United States Environmental Protection Agency

Docket No. EPA-HQ-OLEM-2023-0451

Prepared by: Joshua R. Castigliego, Applied Economics Clinic

Re: Comments on Avoided Emissions from Energy Recovery in EPA’s Waste Reduction Model (WARM) v16

Figure 1. U.S. Census Regions Used in EPA's WARM for Electric Sector Emission Factors

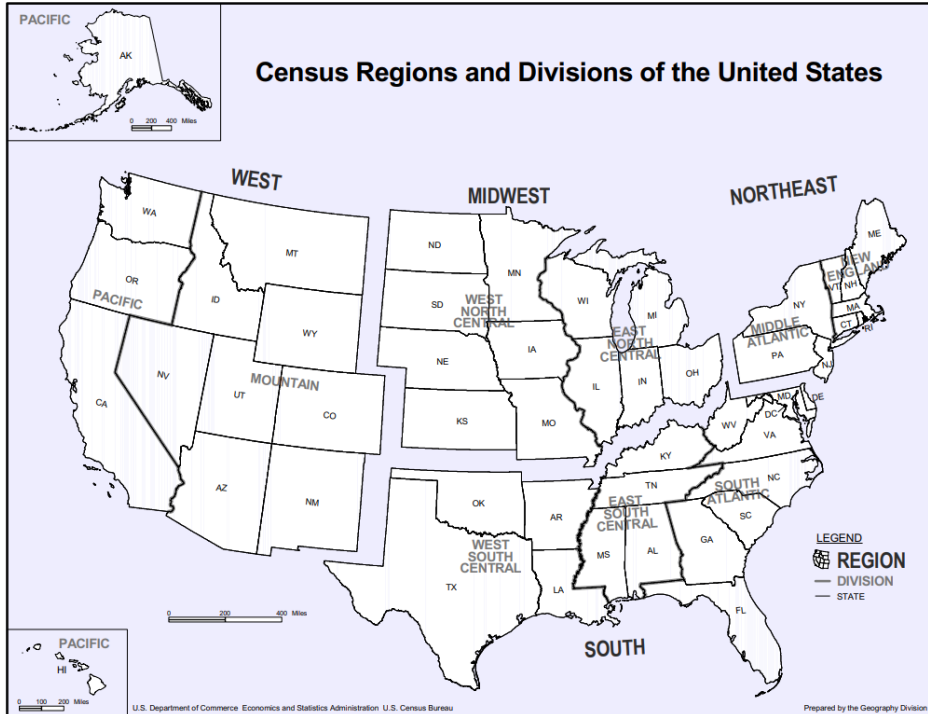
- 4. EPA’s regions are not the regions that organize the electric grid.** EPA’s WARM aggregates its non-baseload emission factors into nine U.S. Census Bureau-designated areas (see Figure 1 below) using eGRID’s state-level data.²² WARM’s geographic regions do not align with the regions defined by real-world electric sector operations and dispatch decisions: ISOs, RTOs and utility service territories (see Figure 2 below). In fact, WARM’s electric utility regions split up highly integrated territories for ISOs and RTOs like PJM, MISO, and SPP, which all have wholesale energy markets with known marginal

resources. WARM's use of regional territories unrelated to the electric sector's operational boundaries is an additional obstacle to producing accurate avoided emission estimates.
